Public Input No. 11-NFPA 13-2018 [Global Input]

Public Input No. 227-NFPA 13-2019 [Global Input]

Figure 8.6.3.1 Arrangement of Supply Piping and Valves.

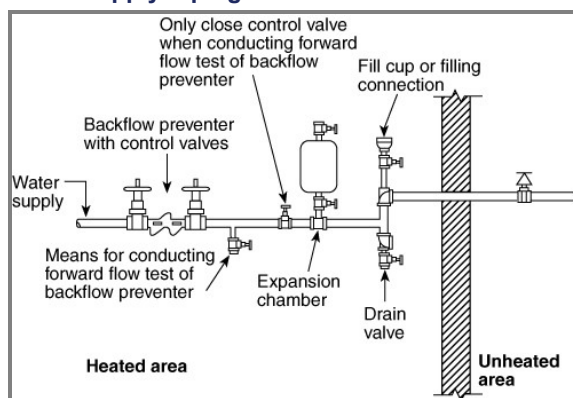
Where the connection between the antifreeze system and the ~~wet pipe system~~ supply piping does not incorporate a backflow prevention device, and the conditions of 8.6.3.5 are not met, piping and valves shall be installed as illustrated in Figure 8.6.3.1.

Resolution: FR-1044-NFPA 13-2019

Statement: The proposed wording change was incorporated in paragraph 8.6.3.2 in the 2019 edition. The rationale for the change is that the wording in the existing language for 8.6.3.1 implies that the required arrangement would only be applicable to an auxiliary antifreeze system that is fed from a wet pipe system. The proposed language would include the requirements of 8.6.3.1 to apply to a stand-

Figure 8.6.3.3 Arrangement of Supply Piping with Backflow Device.

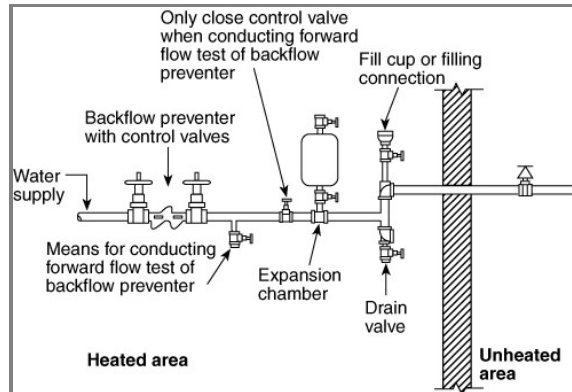
Change figure 8.6.3.3 to add a tee and three way gauge connection valve, gauge and plug between the tank and the tank isolation valve for all bladder and diaphragm type expansion tanks.

Resolution: [FR-1045-NFPA 13-2019](#) All three PI's are accepted and included in the language.

Statement: The existing configuration is unsafe to inspect or test the gas charge of the expansion tank after installation, and removal of the tank if needed must also allow anti-freeze to bleed from the threads as the tank is being removed as there is no other way to drain pressure from the inlet after closing the isolation valve. In order to check the gas pressure the solution must be removed from the bladder or diaphragm type expansion tanks as well, all of which can be accomplished by simply adding this gauge connection.

Figure 10.2.7.1.2(a) Positioning of Sprinkler to Avoid Obstruction to Discharge (SSU/SSP).

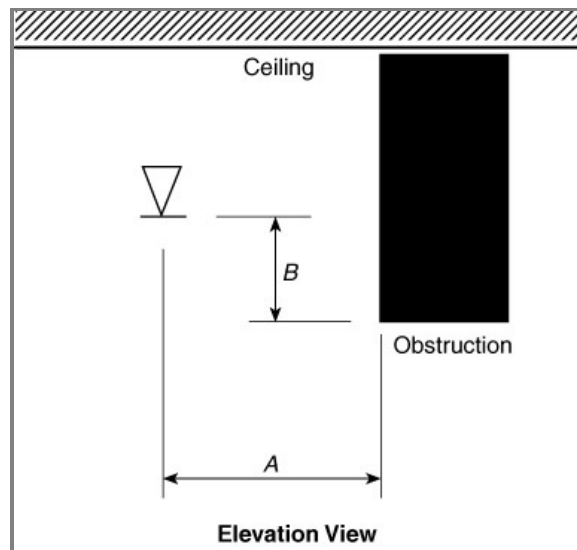
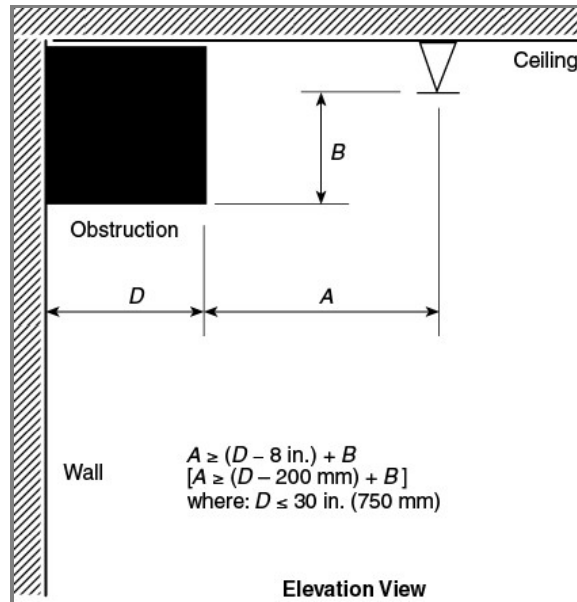
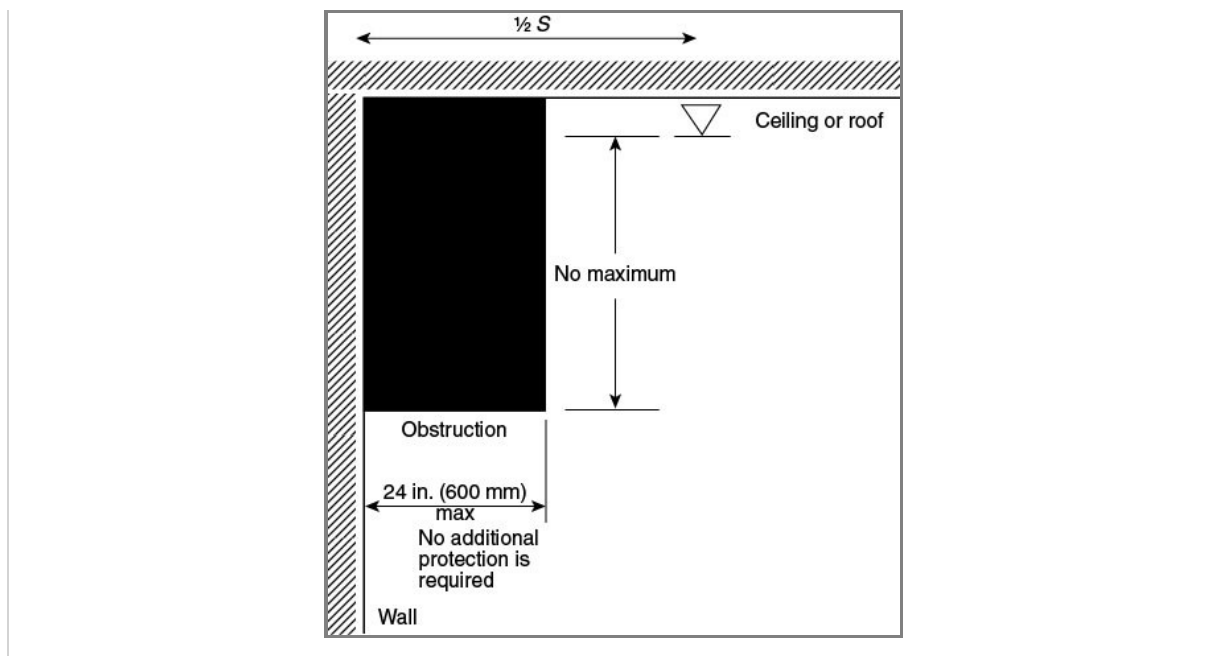
- (1) Subsection 9.5.5.2, Table 10.2.7.1.2, and Figure 10.2.7.1.2(a) shall be followed.
- (2) Sprinklers shall be permitted to be spaced on opposite sides of obstructions not exceeding 4 ft (1.2 m) in width, provided the distance from the centerline of the obstruction to the sprinklers does not exceed one-half the allowable distance permitted between sprinklers.

- (3) Obstructions located against the wall and that are not over 30 in. (750 mm) in width shall be permitted to be protected in accordance with Figure 10.2.7.1.2(b).

- (4) Obstructions located against the wall and that are not over 24 in. (600 mm) in width shall be permitted to be protected in accordance with Figure 10.2.7.1.2(c). The maximum distance between the sprinkler and the wall shall be measured from the sprinkler to the wall behind the obstruction and not to the face of the obstruction.

- (5) Obstructions in hallways up to 6 ft (1.8 m) in width shall be permitted in accordance with figure 10.2.7.1.2(d) when the sprinkler is located in the allowable obstruction zone.

Resolution: [FR-1123-NFPA 13-2019 Use minimum "A" dimension for all beam tables - see attached excel files for new tables. PI 274 is part of FR 1123 with added figures 1\) Horizontal, 2\) pattern development 3\) discharge PI 275 is part of FR 1123 and proposed language is added as item #4 PI 282 is part of FR 1123 adding item #5 New Section 10.2.7.3.2.1 was added based on changes in FR 1132](#)

Figure 11.2.5.1.2(a) Position of Sprinkler to Avoid Obstruction to Discharge (Extended Coverage Upright and Pendent Spray Sprinklers).

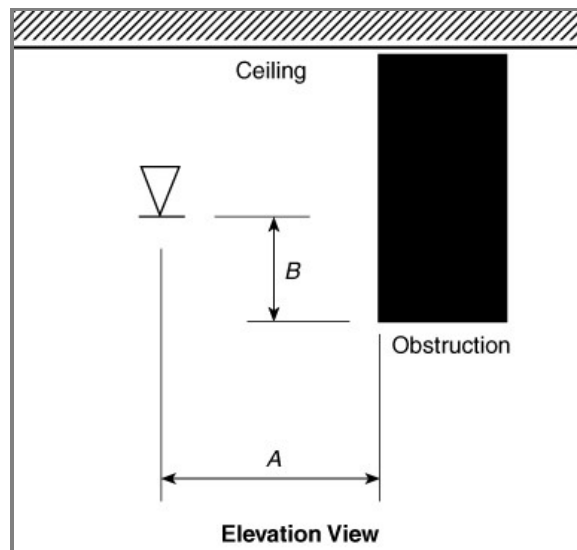
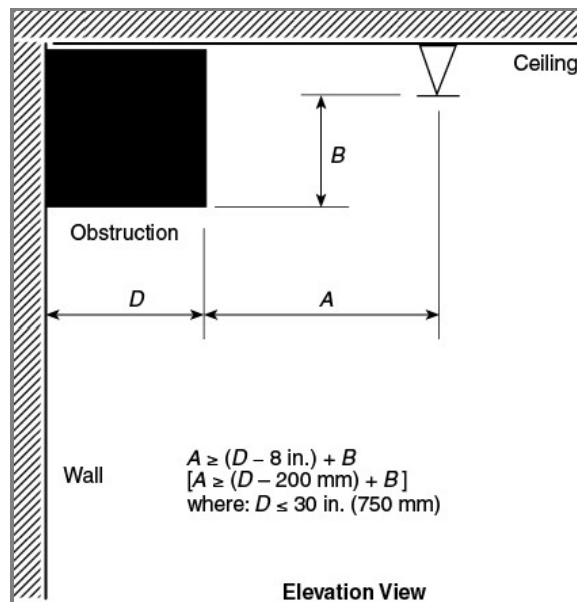
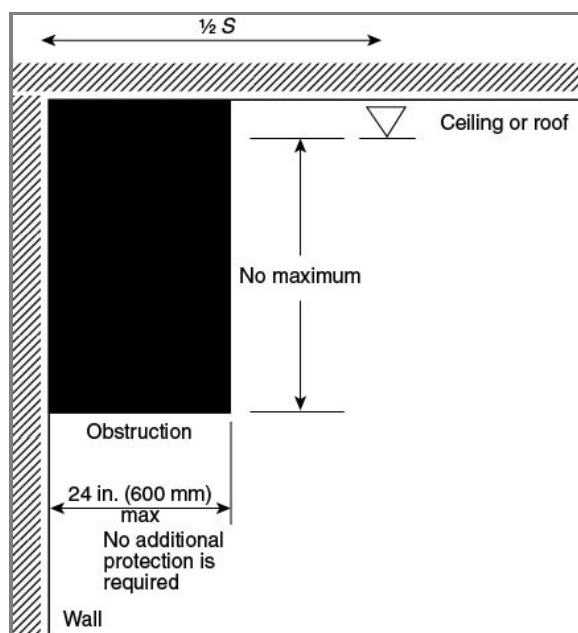
- (1) Sprinklers shall be in accordance with 9.5.5.2, Table 11.2.5.1.2, and Figure 11.2.5.1.2(a).
- (2) Sprinklers shall be permitted to be spaced on opposite sides of obstructions not exceeding 4 ft (1.2 m) in width provided the distance from the centerline of the obstruction to the sprinklers does not exceed one-half the allowable distance permitted between sprinklers.

- (3) Obstructions located against the wall and that are not over 30 in. (750 mm) in width shall be permitted to be protected in accordance with Figure 11.2.5.1.2(b).

- (4) Obstructions located against the wall and that are not over 24 in. (600 mm) in width shall be permitted to be protected in accordance with Figure 11.2.5.1.2(c). The maximum distance between the sprinkler and the wall shall be measured from the sprinkler to the wall behind the obstruction and not to the face of the obstruction.

- (5) Obstructions in hallways up to 6 ft (1.8 m) in width shall be permitted in accordance with figure 11.2.5.1.2(d) when the sprinkler is located in the allowable obstruction zone.

Figure 11.3.6.1.4(a) Positioning of Sprinkler to Avoid Obstruction Along Wall (Extended Coverage Sidewall Spray Sprinklers).

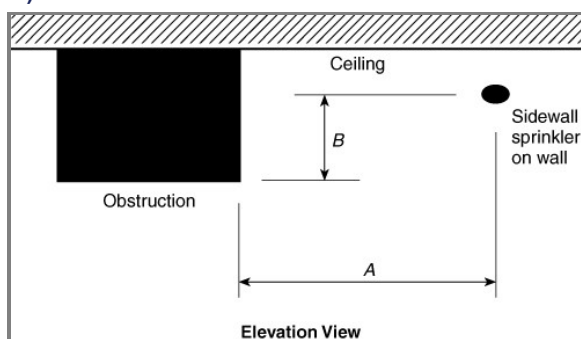
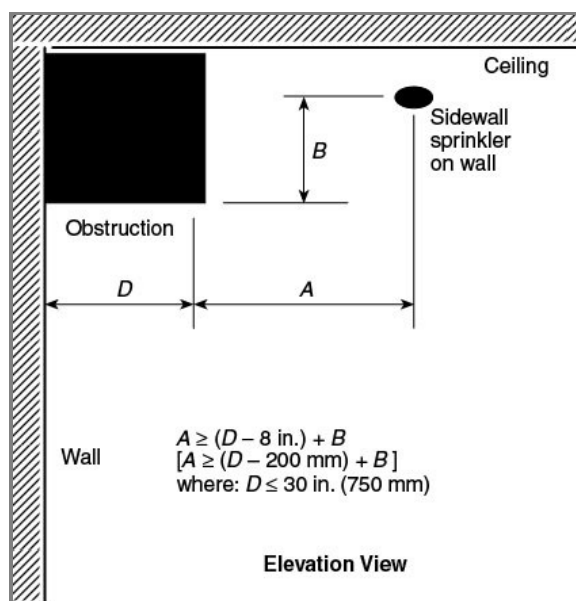
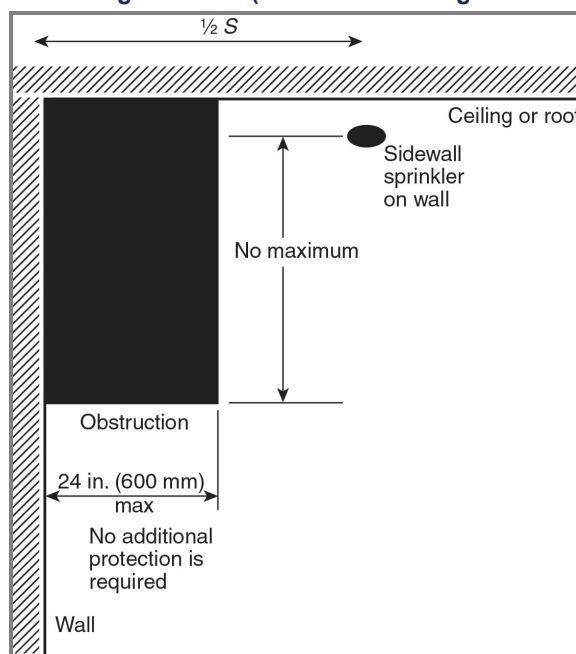
- (1) Sprinklers shall be installed in accordance with Table 11.3.6.1.4 and Figure 11.3.6.1.4(a).
- (2) Sprinklers shall be permitted to be spaced on opposite sides of obstructions less than 4 ft (1.2 m) in width where the distance from the centerline of the obstruction to the sprinklers does not exceed one-half the allowable distance between sprinklers.

- (3) Obstructions located against the wall and that are not over 30 in. (750 mm) in width shall be permitted to be protected in accordance with Figure 11.3.6.1.4(b).

- (4) Obstructions located against the wall and that are not over 24 in. (600 mm) in width shall be permitted to be protected in accordance with Figure 11.3.6.1.4(c). The maximum distance between the sprinkler and the wall shall be measured from the sprinkler to the wall behind the obstruction and not to the face of the obstruction.

- (5) Obstructions in hallways up to 6 ft (1.8 m) in width shall be permitted in accordance with figure 11.3.6.1.4(d) when the sprinkler is located in the allowable obstruction zone.

Figure 12.1.10.1.2(a) Positioning of Sprinkler to Avoid Obstruction to Discharge (Residential Upright and Pendent Spray Sprinklers).

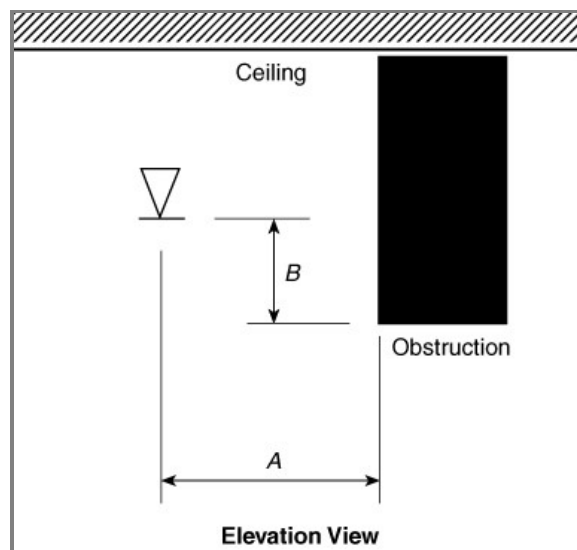
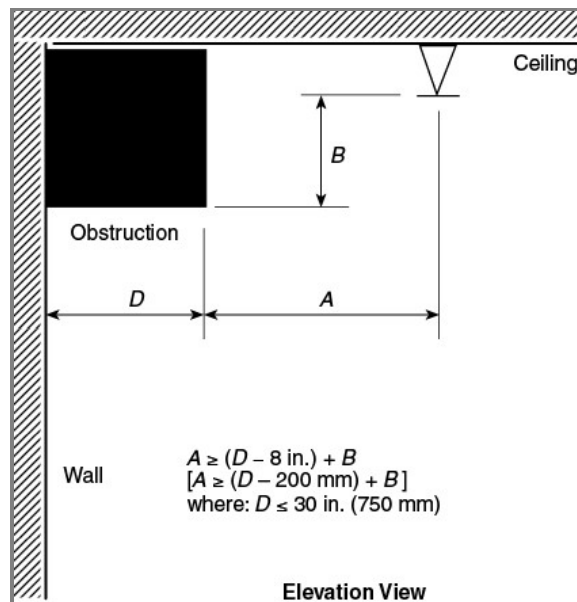
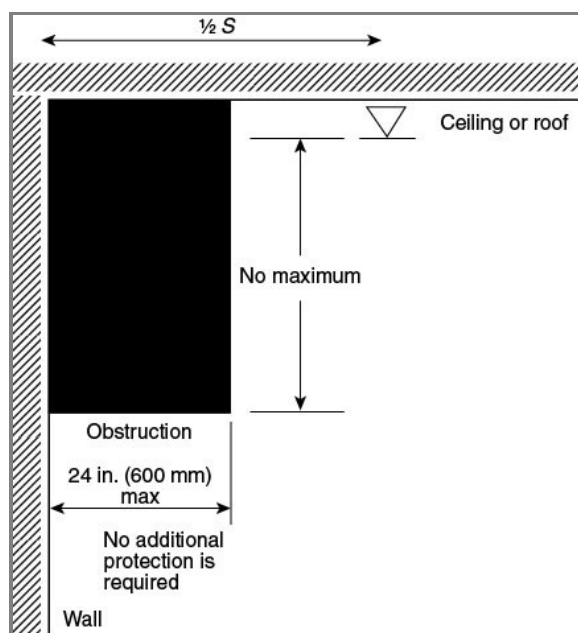
- (1) Sprinklers shall be in accordance with 9.5.5.2, Table 12.1.10.1.2, and Figure 12.1.10.1.2(a).
- (2) Sprinklers shall be permitted to be spaced on opposite sides of obstructions not exceeding 4 ft (1.2 m) in width, provided the distance from the centerline of the obstruction to the sprinklers does not exceed one-half the allowable distance permitted between sprinklers.

- (3) Obstructions located against the wall and that are not over 30 in. (750 mm) in width shall be permitted to be protected in accordance with Figure 12.1.10.1.2(b).

- (4) Obstructions that are located against the wall and that are not over 24 in. (600 mm) in width shall be permitted to be protected in accordance with Figure 12.1.10.1.2(c). The maximum distance between the sprinkler and the wall shall be measured from the sprinkler to the wall behind the obstruction and not to the face of the obstruction.

- (5) Obstructions in hallways up to 6 ft (1.8 m) in width shall be permitted in accordance with figure 12.1.10.1.2(d) when the sprinkler is located in the allowable obstruction zone.

Figure 12.1.11.1.4(a) Positioning of Sprinkler to Avoid Obstruction Along Wall (Residential Sidewall Sprinklers).

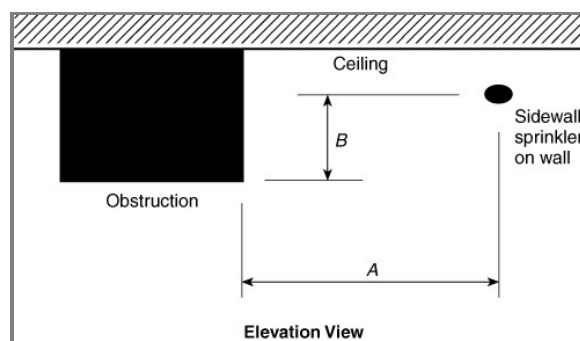
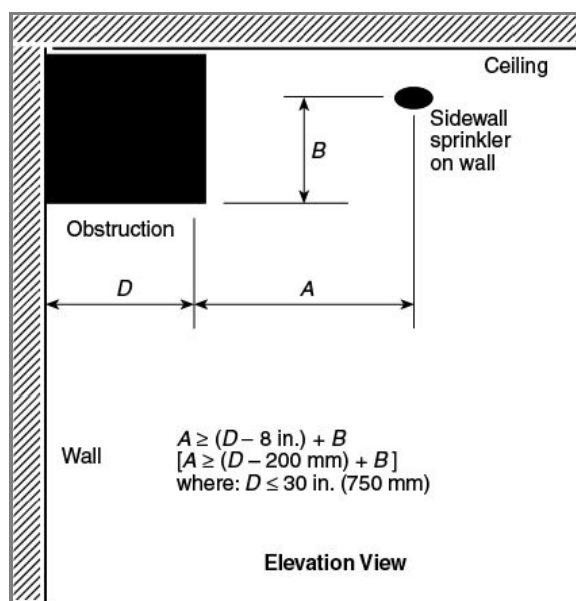
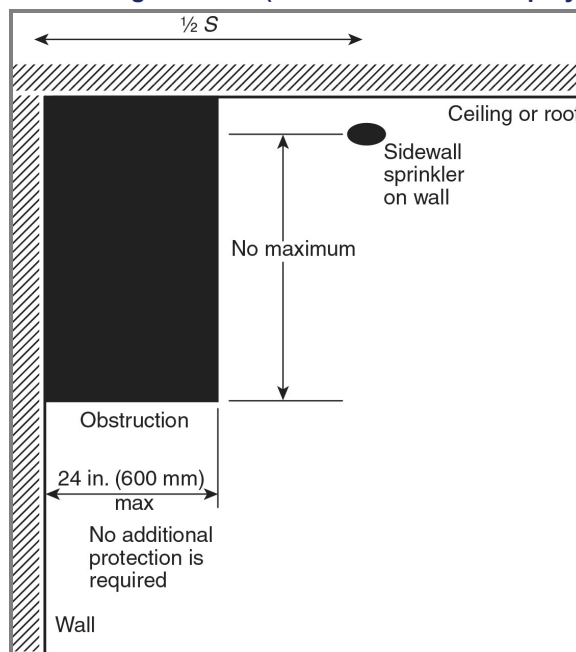
- (1) Sprinklers shall be in accordance with Table 12.1.11.1.4 and Figure 12.1.11.1.4(a).
- (2) Sprinklers shall be permitted to be spaced on opposite sides of obstructions less than 4 ft (1.2 m) in width where the distance from the centerline of the obstruction to the sprinklers does not exceed one-half the allowable distance between sprinklers.

- (3) Obstructions located against the wall and that are not over 30 in. (750 mm) in width shall be permitted to be protected in accordance with Figure 12.1.11.1.4(b).

- (4) Obstructions located against the wall and that are not over 24 in. (600 mm) in width shall be permitted to be protected in accordance with Figure 12.1.11.1.4(c). The maximum distance between the sprinkler and the wall shall be measured from the sprinkler to the wall behind the obstruction and not to the face of the obstruction.

- (5) Obstructions in hallways up to 6 ft (1.8 m) in width shall be permitted in accordance with figure 12.1.11.1.4(d) when the sprinkler is located in the allowable obstruction zone.

Figure A.10.2.6.1.4.5 Hip Roof Installations.

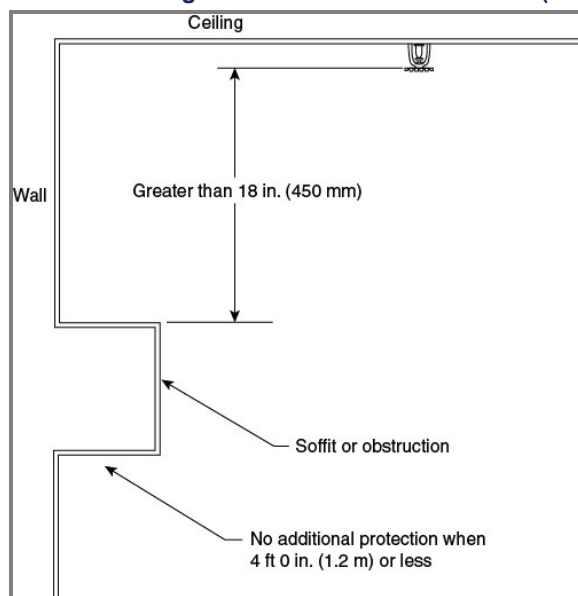
Current dimensions on Fig A.10.2.6.1.4.5 are confusing and one appears incorrect. Attempts to clarify intent of the figure.

Resolution: [FR-1167-NFPA 13-2019](#)

Statement: Current dimensions on Fig A.10.2.6.1.4.5 are confusing and one appears incorrect. Attempts to clarify intent of the figure.

Figure A.10.2.7.1.2 Soffit/Obstruction Against Wall Greater Than 18 in. (450 mm) Below Deflector.

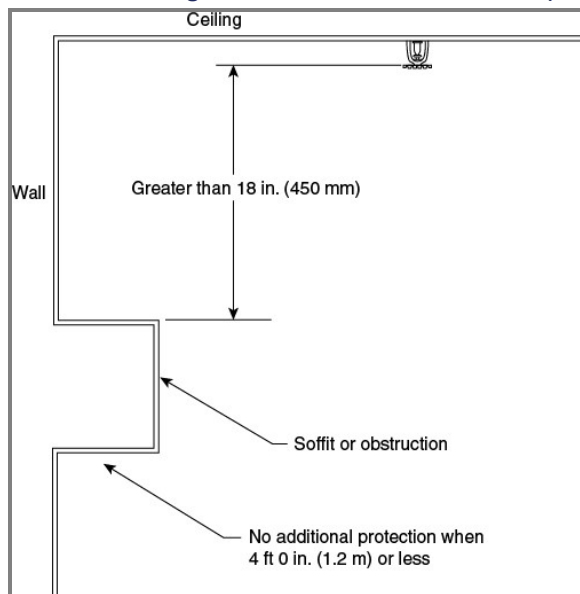
The intent of 10.2.7.1.2(3) is to apply to soffits that are located within the 18 in. (450 mm) plane from the sprinkler deflector. A soffit or other obstruction (i.e., shelf) located against a wall that is located entirely below the 18 in. (450 mm) plane from the sprinkler deflector should be in accordance with 10.2.7.3.2. (See Figure A.10.2.7.1.2.)

Resolution: [FR-1169-NFPA 13-2019 PI 410 resolved based on FR 1169](#)

Statement: No guidance provided on minimum distance from the soffit.
